TECHNICAL BULLETIN

EQUIPMENT MAINTENANCE – PREVENTATIVE ACTION REQUIRED

SUBJECT: PEELLE 250723 PINION GEAR

EQUIPMENT: PEELLE CAR DOOR OPERATORS (PART NUMBERS: 2518, 2517, 2548, 2547, 2528, 2527 AND 2549)

250723 PINION GEAR

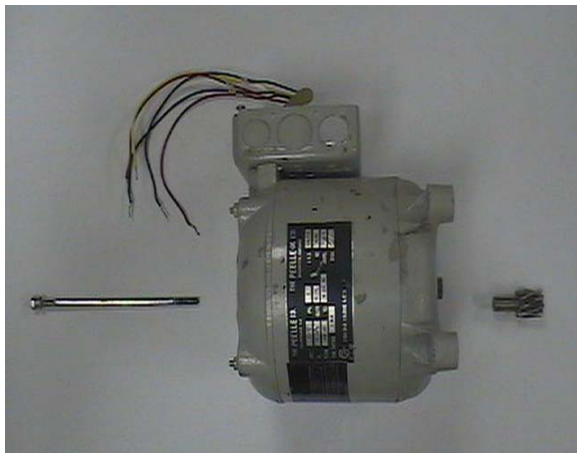
DESCRIPTION: PEELLE HAS DISCOVERED THAT THE MATERIAL USED FOR THE 250723 PINION GEAR ON THE ABOVE LIST OF CAR DOOR OPERATORS WAS NOT MANUFACTURED TO PEELLE'S HARDNESS SPECIFICATION. THIS COULD RESULT IN PREMATURE PINION WEAR. THIS APPLIES TO JOBS SHIPPED BETWEEN JANUARY 1ST 2002 AND OCTOBER 30TH 2002.

JOBS SHIPPED AFTER NOVEMBER 1ST 2002 HAVE BEEN CORRECTED.

ACTION: CONTACT PEELLE FOR A FREE REPLACEMENT 250723 PINION GEAR. FOR USA – CONTACT 1-800-645-1056 EXT. 11 LAURA NEUMANN. FOR CANADA AND INTERNATIONAL – CONTACT 905-846-4545 EXT. 220 LEN HOUWEN. TO REPLACE 250723 PINION GEAR:

1. TURN OFF POWER.
2. UNBOLT GATE MOTOR.
3. REMOVE CAP AT BACK OF MOTOR.
4. UNSCREW PINION BOLT EXCEPT FOR THREE THREADS.
5. HAMMER PINION BOLT HEAD TO LOOSEN PINION.
6. EXCHANGE PINION AND REASSEMBLE.
